UNITED STATES PATENT AND TRADEMARK OFFICE

10/578,421

Office Action Summary	Application No. 10/578,421	Applicant(s) KANG ET AL.	
	Examiner DANIEL KENNY	Art Unit 3633

DETAILED ACTION

Annotated Fig. 4 (6,739,937)

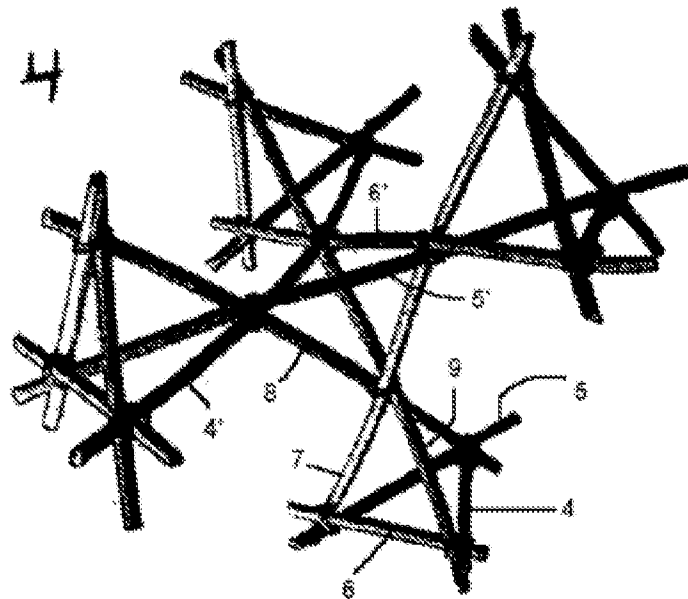
Snelson discloses a structure (Fig. 4 below) comprising:

Claim 1 - a) a first tetrahedron member formed of a first to sixth wires, the first tetrahedron member being constructed in such a manner that the first wire (4), the second wire (5), and the third wire (6) are intercrossed in a plane to form a triangle, the fourth wire (7) is intercrossed with the intersection point of the second wire and the third wire, the fifth wire (8) is intercrossed with the intersection point of the first wire and the second wire, and the sixth wire is intercrossed with the intersection point of the third wire and the first wire, the fourth wire, the fifth wire, and the sixth wire (9) being intercrossed with one another at a single reference intersection point; and

b) a second tetrahedron member contacted with the first tetrahedron member at the reference intersection point and having a similar shape to the first tetrahedron member, the second tetrahedron member being constructed in such a manner that the fourth wire, the fifth wire, and the sixth wire pass the reference intersection point and extend further, each of a group of wires (4', 5', 6') is intercrossed with two wires selected from the extended fourth, fifth and sixth wires, the group of wires being in parallel with the first wire, the second wire, and the third wire respectively; and

and the unit cell is repeated in a three-dimensional pattern, thereby forming a wire (or rod)-woven truss-type structure.

Finally, the Snelson-taught wire members need not be bonded at intersection points ("joining members are not required", para. 36, last sentence).
